# UNITED STATES PATENT AND TRADEMARK OFFICE

APPLICATION NO.	FILING DATE	FIRST NAMED INVENTOR	ATTORNEY DOCKET NO.	CONFIRMATION NO.
10/711,658	09/29/2004	David E. Henderson	PES-0218	5657

## Office Action Summary

## DETAILED ACTION

Figure 1

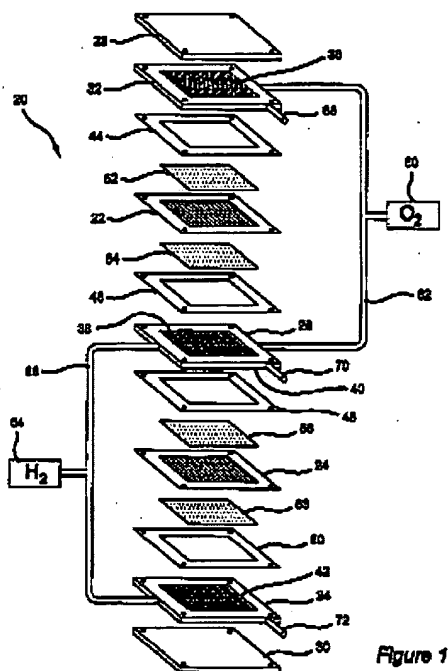
Lisi teaches that it is conventional to employ a plurality of MEAs (22, 24) alternatively arranged with a plurality of flow field members (38, 40) between first and second separator plates (32,34). See Figure 1.

However, it would have been obvious to one of ordinary skill in the art at the time the instant invention was made to employ the fuel cell stack assembly of Lisi, using the MEAs of Cavalca, in order to fulfill greater load demands (claims 16 & 19). The skilled artisan recognizes that employing multiple MEAs in a stack provides greater electrical output. Additionally, it would have been obvious to one having ordinary skill to employ multiple MEAs in stack configuration, since it has been held that mere duplication of the essential working parts of a device involves only routine skill in the art. *St. Regis Paper Co. v. Bemis Co.*, 193 USPQ 8.
